2012 update of OPTA's fixed and mobile BULRIC models

Response to the public consultation

27 June 2013 • 37097-262 PUBLIC VERSION

Figure 1: Loading curves used in the v5 model [Source: v5 model, 2013]

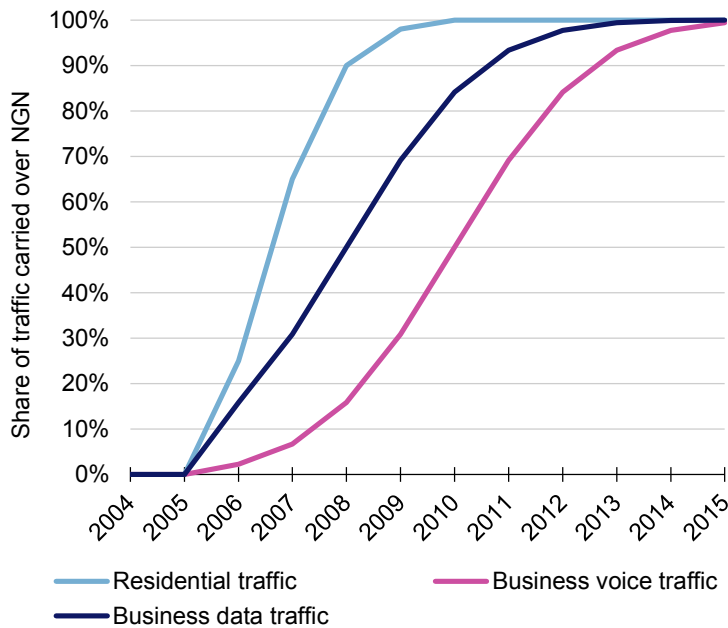
- Ziggo: An NGN using VoIP does not reflect the current market – more than half of customers use traditional PSTN.
- UPC: Fixed voice traffic will decline further as OTT applications in the fixed network grow.

The loading curves used for the fixed NGN network in the v5 model are shown in Figure 1 below.

These loading curves reflect the fact that it takes some time for all traffic to be moved across to the NGN, however it may be that KPN or the cable operators have chosen to migrate more slowly in order to utilise existing assets for longer, or for other (e.g. retail) reasons.

Consequently, we consider that an all-IP NGN model for the fixed core network is an efficient choice, and the application of load-up curves acting over a number of years reflects the situation where customers move across from the legacy to the new technology over time, but in an overall efficient manner.

Figure 3: Pure BULRIC cost allocation [Source: Analysys Mason, 2013]

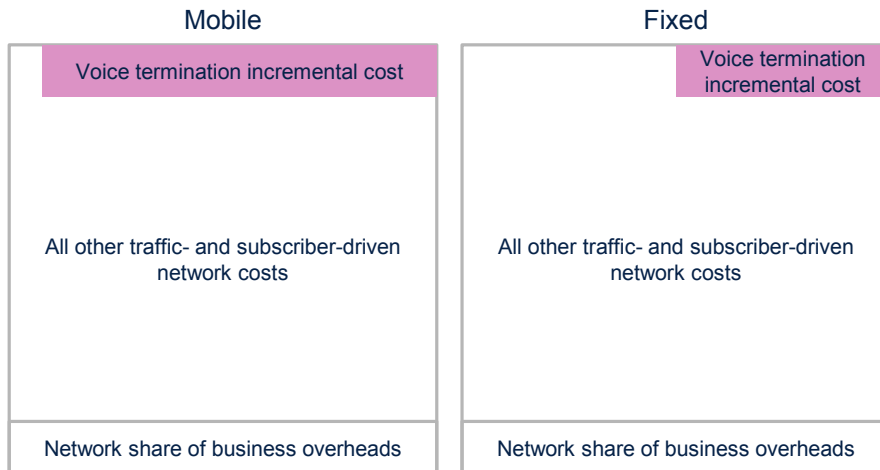
- Ziggo: It is not clear why subscriber-driven and fixed costs in the voice platform are excluded.
- KPN: It seems incorrect to model VoIP hardware and software in a separate model then to change only the software costs used in the model.

The diagrams in Figure 3 below illustrate the costs included in the unit cost of terminated traffic in both the mobile and fixed pure BULRIC calculations.

As the fixed and subscriber-driven voice platform costs would not be affected by the removal of fixed termination traffic, these do not fit into the relevant increment and are therefore not part of the pure BULRIC cost of fixed termination.

Figure 5: Assumptions for mobile voice traffic in the v5 model
[Source: v5 model, 2013]

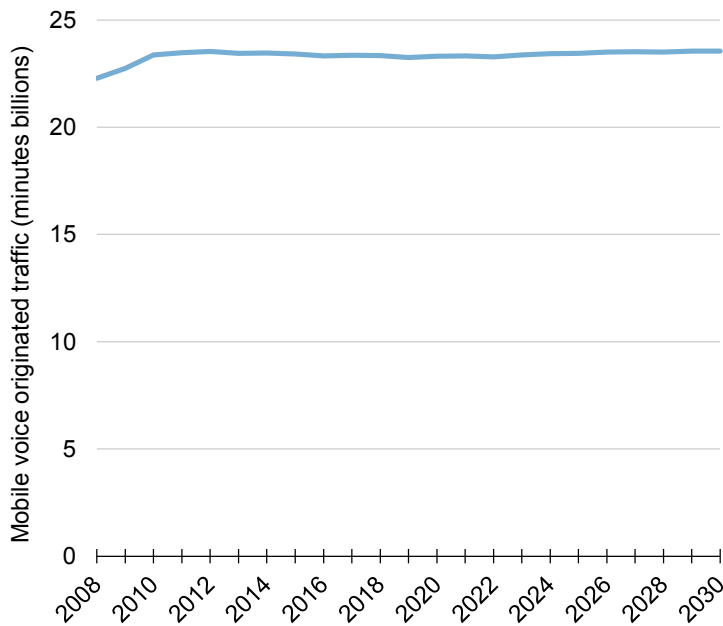
- T-Mobile: Mobile voice traffic is expected to decline further, e.g. due to OTT mobile voice.

The mobile voice traffic forecast used in the v5 model has already been discussed in Section 2.1.2 of the response document. The historical mobile voice minutes used in the v5 model are sourced from OPTA historical market data to 2011. From the OPTA market data⁵ we observe that mobile voice minutes were already relatively static over the period December 2009–June 2012, and as a result have forecast total voice traffic so that mobile-originated traffic remains static, as shown in Figure 5 below.

As discussed in Section 5.2 earlier, we believe any potential future increase in the popularity of OTT applications is adequately taken into consideration in our voice traffic forecasts.

Figure 6: Forecast for SMS traffic in the v5 model [Source: v5 model, 2012]

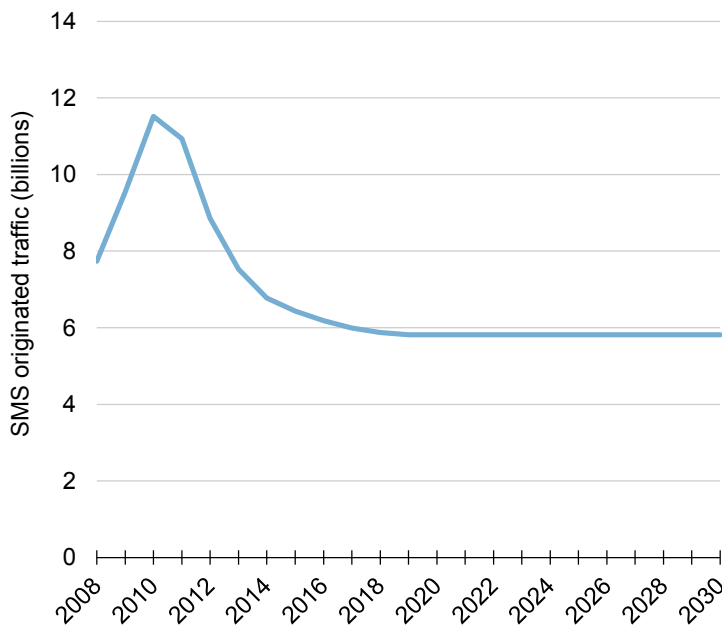
- T-Mobile: The decrease in SMS will be much larger than modelled, e.g. due to OTT messaging.

The mobile SMS traffic forecast used in the v5 model has already been discussed in Section 2.1.2 of the response document. The forecasts were updated using OPTA Market Monitor data⁵ on historical SMS traffic. We said “*This data showed that between year-end 2010 and half-year 2012 SMS volumes have decreased at a compound annual growth rate (CAGR) of -19%. We have assumed this is the decline experienced between 2011 and 2012. We have then assumed the year-on-year decline reduces to zero by 2019.*”

These SMS traffic forecasts are shown in Figure 6 below, where it can be seen that there is a significant reduction in the traffic. As for voice traffic (see Sections 5.2 and 8.2 above), we believe that this forecast reduction is sufficient to take into account any reduction in SMS traffic from the adoption of OTT messaging. The overall influence of the SMS forecast on the results of the model

is relatively limited therefore we believe that the reduction adopted already is reasonable for the purposes of the next regulatory period.

Figure 8: Number of BTSs versus spectrum
[Source: Analysys Mason, 2013]

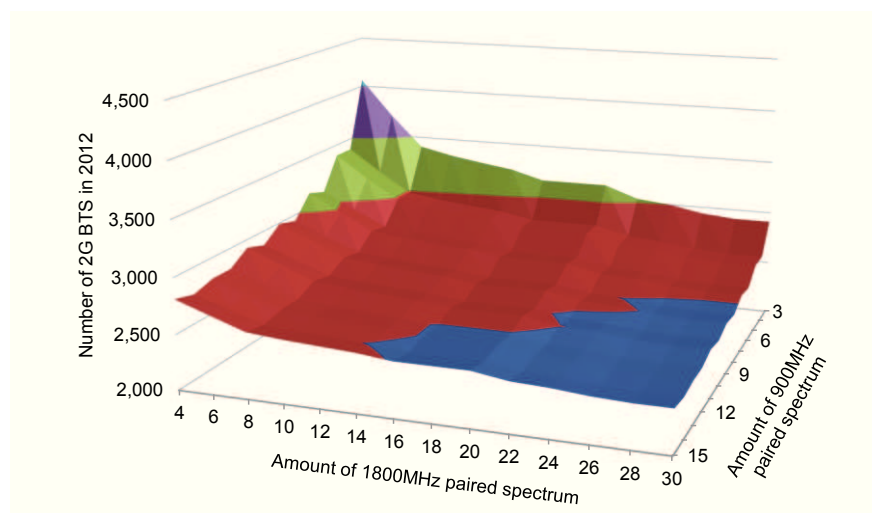
- Vodafone: No spectrum is considered incremental to the termination service and this is an error: either an amount of spectrum should be considered incremental, or the value of spectrum should change with the level of traffic carried.
- Vodafone: A rational operator would seek to avoid more expensive 900MHz spectrum first.

In Section 3.4.4 of the response document we presented a ‘surface’ chart (Figure 3.12) showing that the v5 model was sensitive to the amount of paired 900MHz spectrum and the amount of paired 1800MHz spectrum applied in the model, such that in all cases:

- a reduction in the amount of 1800MHz spectrum causes an increase in GSM base stations
- a reduction in the amount of 900MHz spectrum causes an increase in GSM base stations
- a reduction in the amount of both spectrum bands causes an increase in GSM base stations.

This chart confirms our conclusion, and the behaviour of the model, that reducing the spectrum allocation in the network requires more sites to serve the traffic load. This chart also shows that the trend is always in the same direction – reducing the spectrum available always causes an increase in the requirement for sites.

Figure 12: Updated migration profile showing actual and forecast values
[Source: Analysys Mason, 2013]

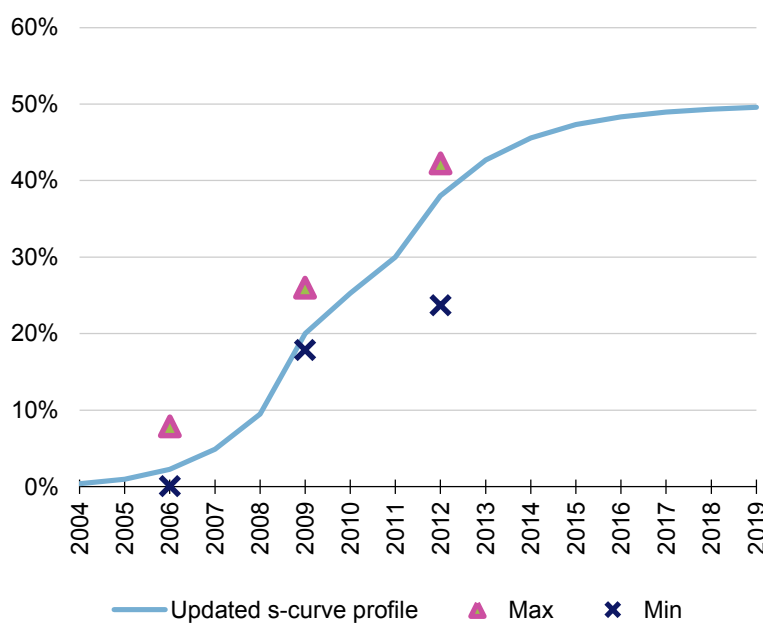
- Vodafone: Evidence was provided of the need to increase the busy-hour factor to reflect cell-by-cell and seasonal variability over the network average. This adjustment should be applied without also applying further 'compensating adjustments not supported by evidence'.
- Vodafone: Vodafone's site count [3<] is around [3<] higher than the number of sites in the hypothetical 33% operator model, despite Vodafone carrying [3<] of the market traffic.

- the operator-specific 2G–3G migration profiles used in the calibration tests show a slightly stronger migration from 2G to 3G traffic than applied in the hypothetical operator model. This average migration profile is now applied in the hypothetical operator case and thereafter projected from around 40% in 2012 to 50% in the long term, as shown in Figure 12.

Data was submitted by Vodafone in its public consultation response [3<]. For comparison, the updated hypothetical operator model now contains 4463 macro sites and 425 micro sites in 2011.
